SERVICE BULLETIN
SUMMARY

T I T L E : AIR CONDITIONING - PRESSURIZATION AND PNEUMATIC SYSTEM - INSTALL

ADDITIONAL BONDING STRAP

SERVICE BULLETIN No. : A320-21-1008

Installation of Bonding Strap Figure 1, Sheet 1 of 2

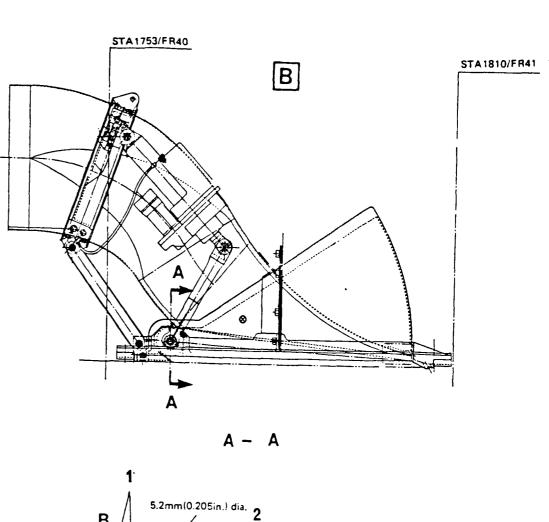
- (1) Drill and debur a hole dia. 5.2 mm (0.205 in.) and two rivet holes dia. 2.4 mm (0.094 in.) for the anchor nut attachment on ram air outlet to dimensions as given on Sheet 1 of 2.
- (2) Install anchor nut MS21047-L3, item 3, with rivets MS20426AD3-8, item 1.
- (3) Provide a blank surface dia. 13 mm (0.512 in.) for bonding connection (Ref. AMM 20-28-11, P. Block 201).
- (4) Install one end of bonding strap ABS0394C-125, item 2, to the ram air outlet with bolt NAS6703U4, item 8 and washer AN960C10L, item 5.
- (5) Cut and remove the lockwire from bearing of movable flap.
- (6) Remove and retain the screw, item 4.
- (7) Provide a blank surface dia. 13 mm (0.512 in.) for bonding connection (Ref. AMM 20-28-11, P. Block 201).
- (8) Install the other end of bonding strap, item 2 to the bearing of movable flap with the retained bolt NAS6703HU1, item 4 and a new washer AN960C1OK, item 5.

Installation of Bonding Strap Figure 1, Sheet 2 of 2

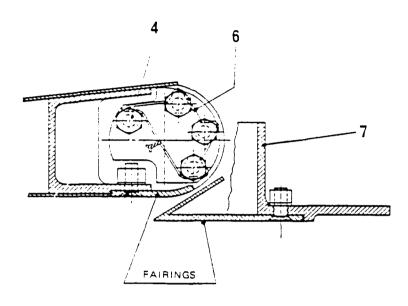
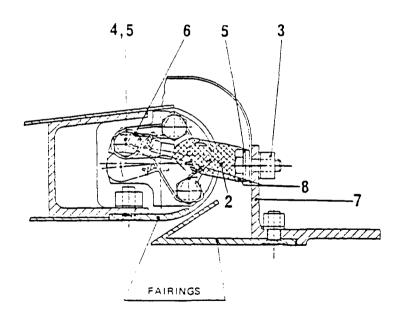
(9) Secure with the new Lockwire MS20995C32, item 6, as given on Sheet 2 of 2.

NOTE: As an alternative each pair of bolts can be secured with lock-wire separately.

- (10) Apply protective coat with lacquer Nycote 7-11 and color powder Nycote blue to bolts and rivet heads and cover the remaining blank area of the bonding connection with sealant Mat. No. 09-015 or Mat. No. 09-013 (Ref. AMM 20-31-00).
- (11) Re-identify ram air outlets as per Para. 3.D.
